Re: Mims Park – Athletic Restrooms and Concessions

Project #PR-048-24B

Date: November 18, 2024

2 - 2" Water Meters

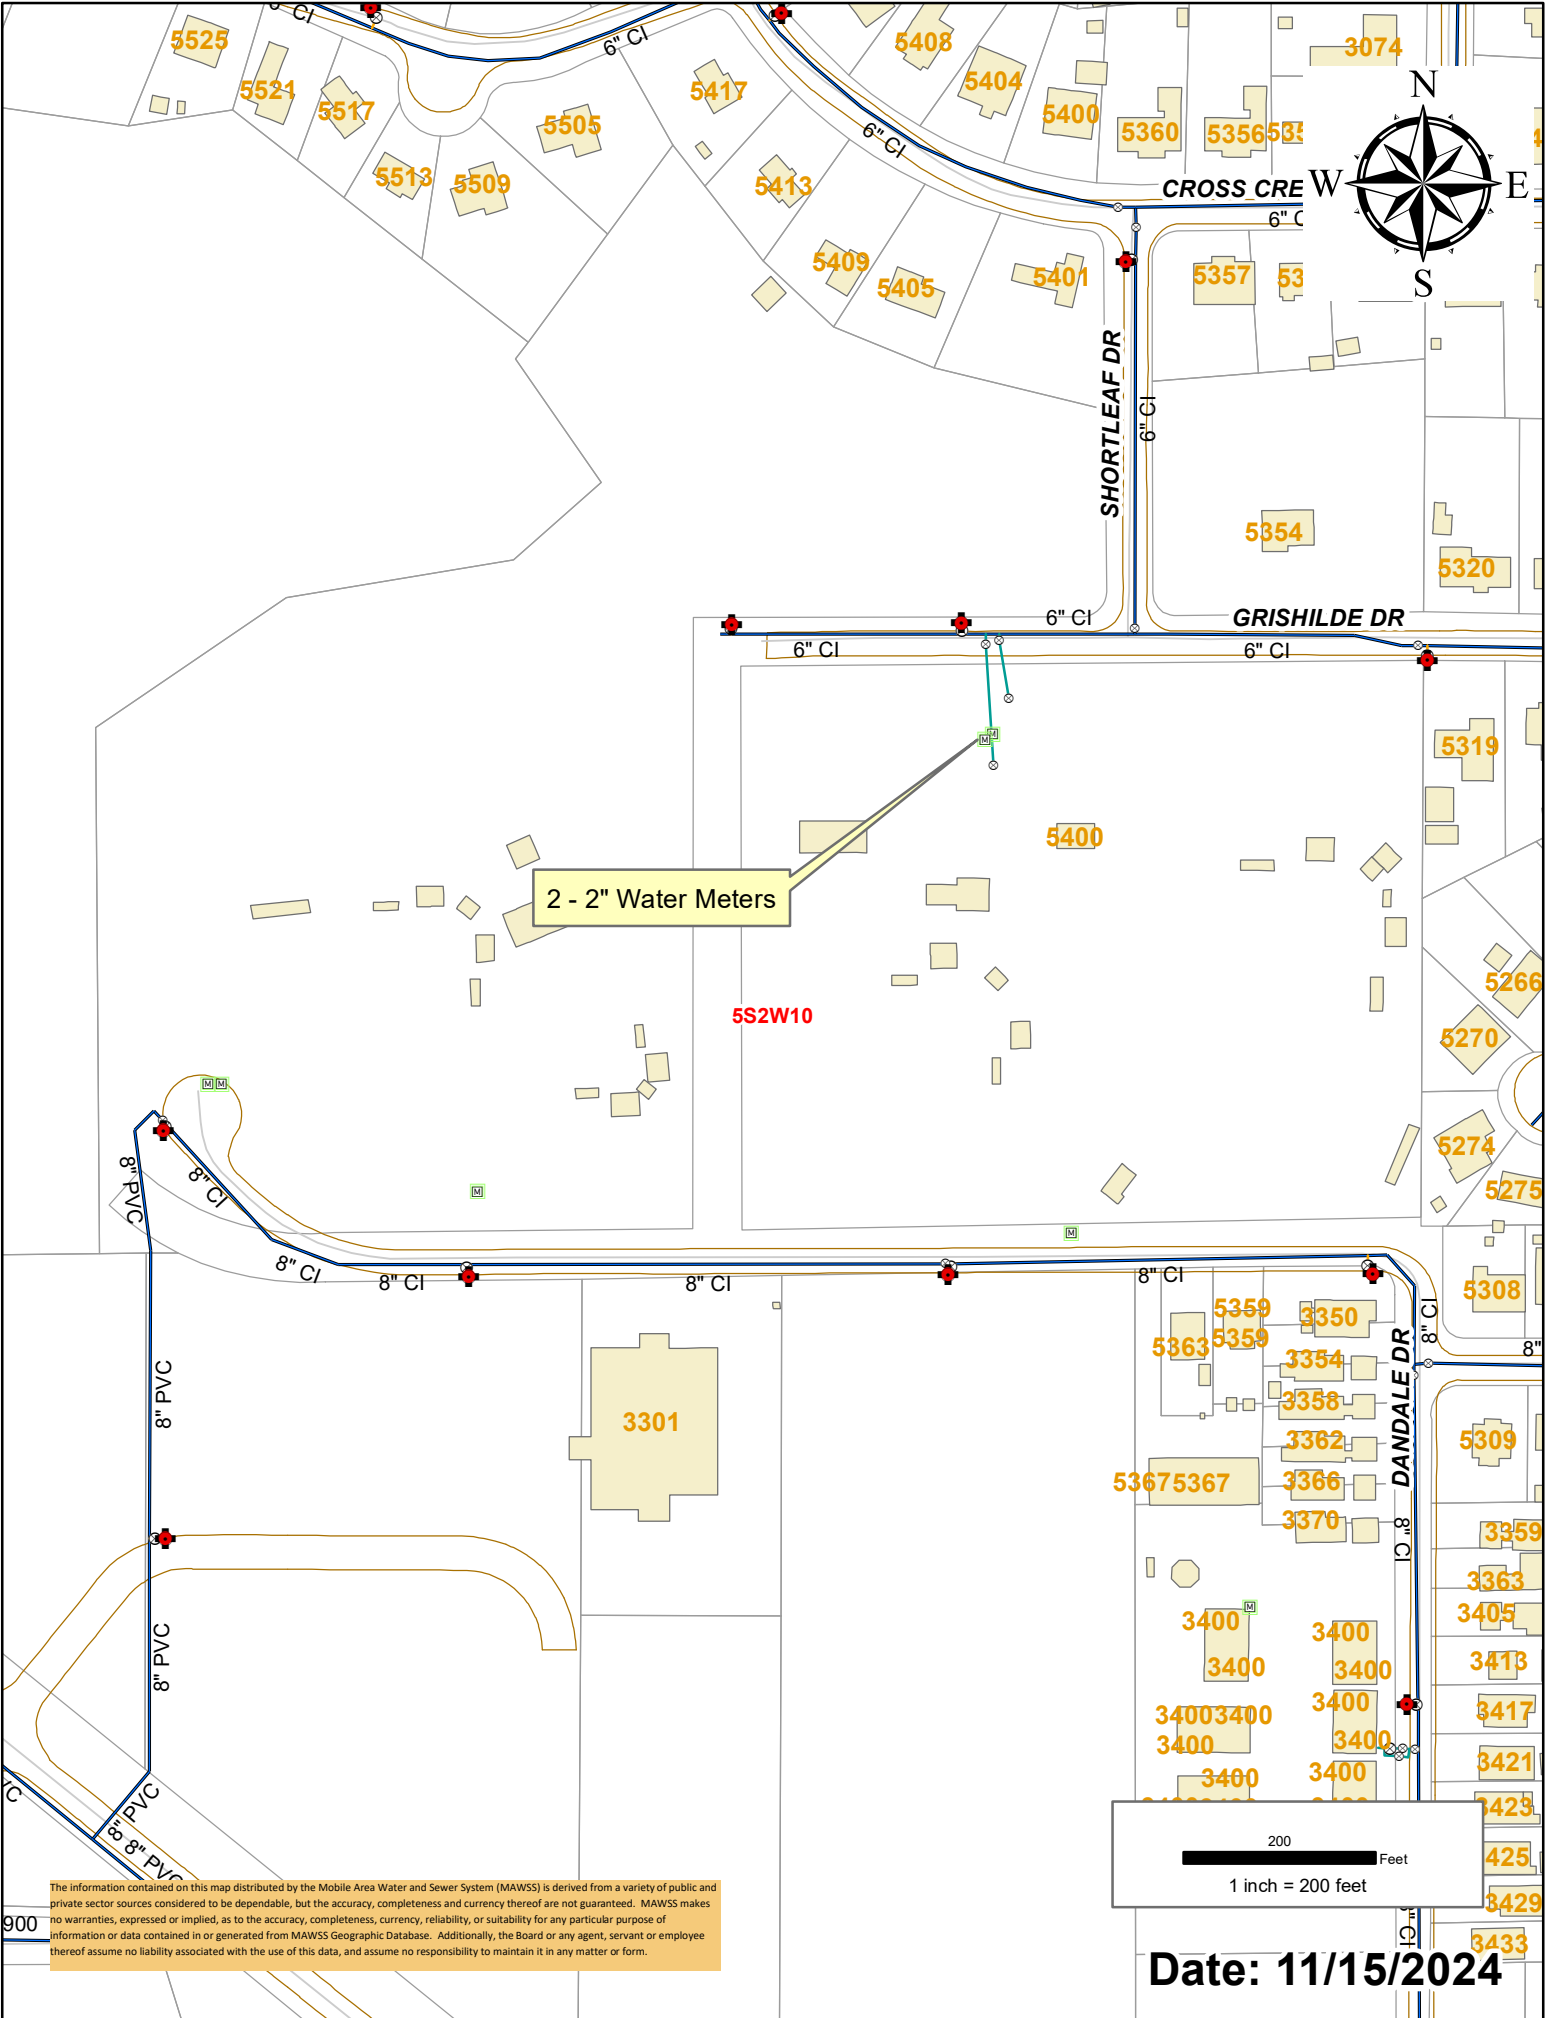
Item 3. In regards to the existing Water Service lines, per the plan it was noted to “VERIFY W/ UTILITY OWNER FOR IF BACKFLOW PREVENTOR IS NECESSARY FOR THE NEW BUILDING” MAWSS has confirmed that there are 2-2” water meters which exist and will be require

for 2-new 2” Backflow Preventors to be installed. Each BFP shall be above ground mounted double-check valve assemblies with protection installed on each for freeze protection and bollards will be required to protect from vehicles. Note, MAWSS has advised that if the water service meters are currently off and in need to be turned on then for turning on the water then this shall be communicated through MAWSS Customer Service (251) 694-3100.

Sewer Lateral to be replaced

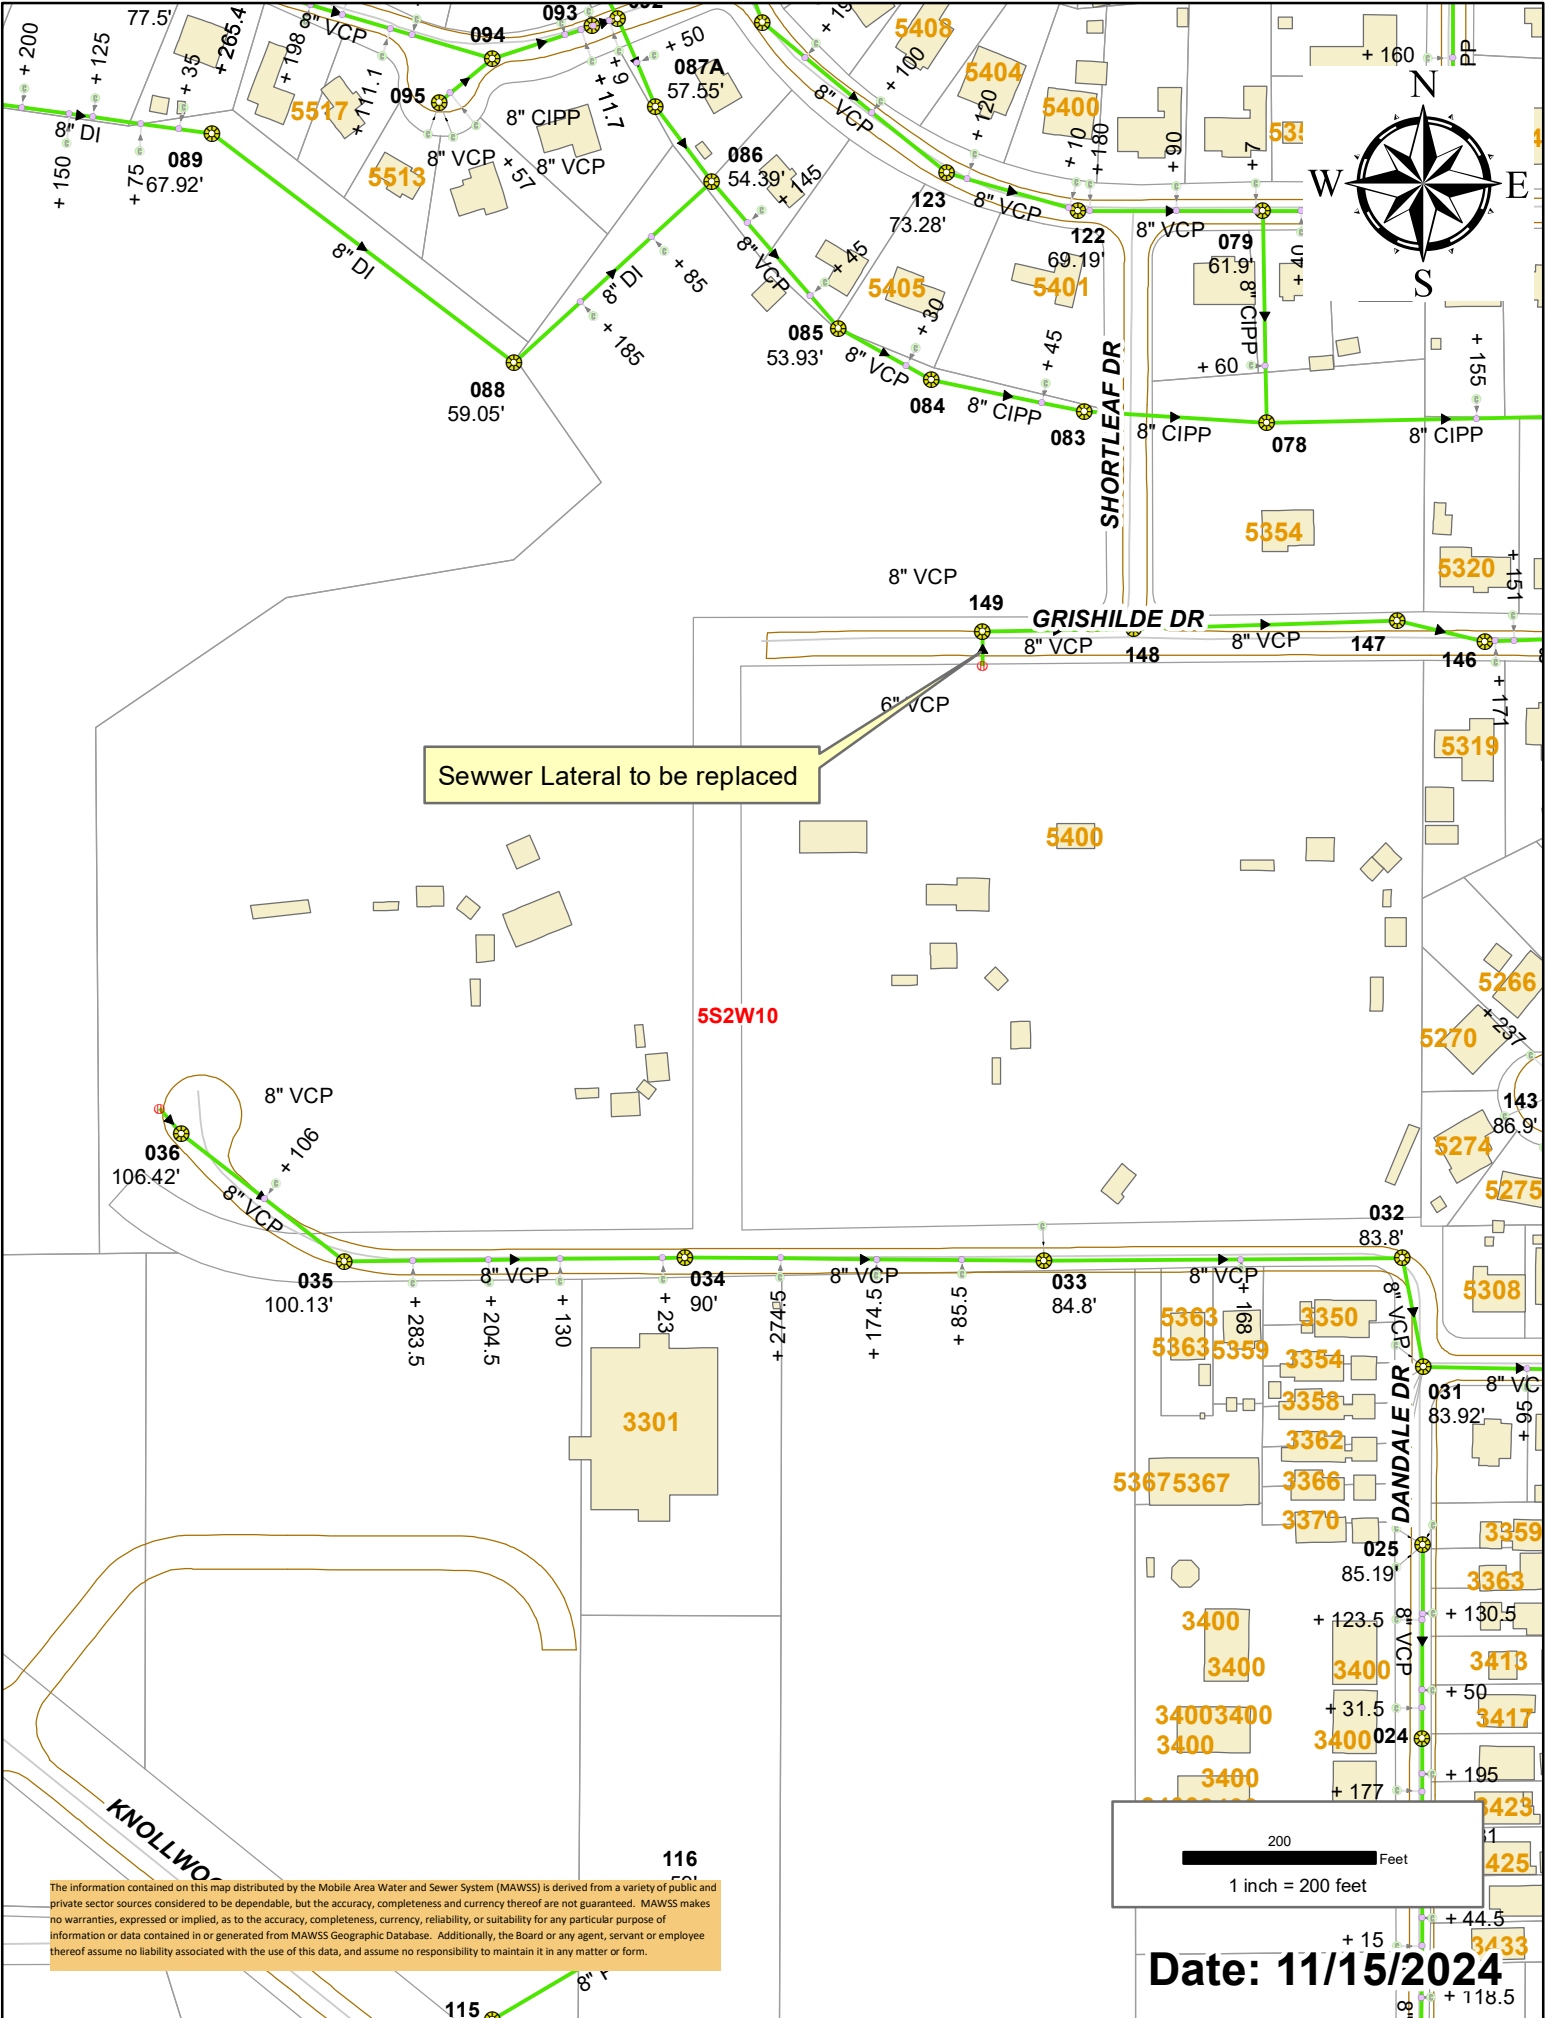
Item 2. MAWSS currently is slated to replace their portion of the existing 6” VCP sanitary sewer lateral approximately 36’ from the manhole within the right-of-way of Grishilde Drive. At the end of the replaced sanitary sewer lateral MAWSS will install a 6” cleanout which is anticipated to be within the driveway pavement. MAWSS typically squares off the cut for their permanent repair for contractor to come in and replace, however the City’s contractor will be responsible for coordinating the responsibility of the permanent repair of the road.
